Site: 10 Prospect Street

Case #: PB 2019-04

Date: April 18, 2019

PRELIMINARY STAFF REPORT

Thermal Impacts on Facades

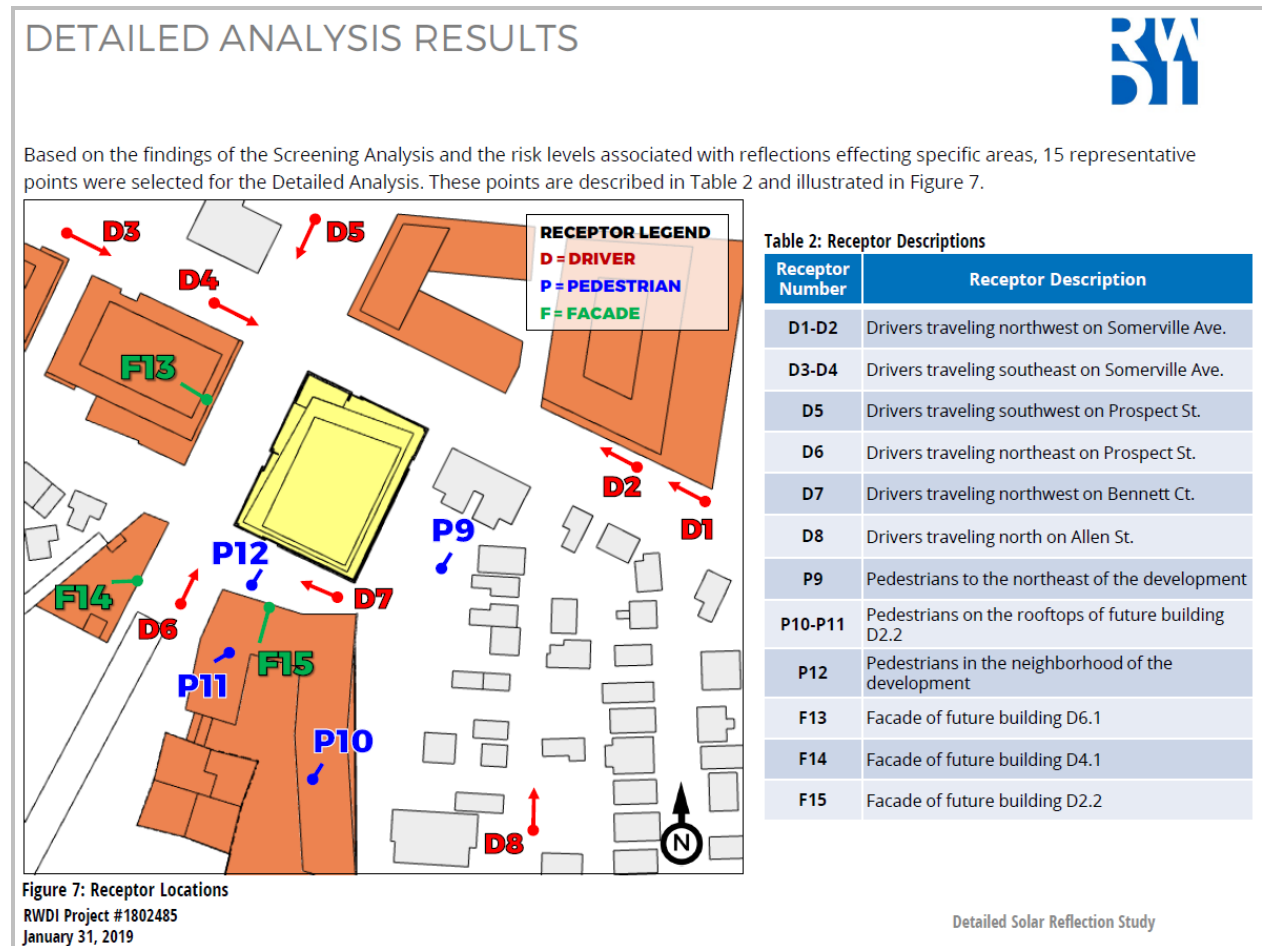
At all studied facade areas, reflections are of low intensity and short duration. Hence, we would not expect these reflections to lead to a significant additional cooling load for a building. Should

an individual choose to expose themselves to the reflected energy through a window, they may feel warm; however, this would be a temporary experience and one which would easily be remedied by closing window treatments.
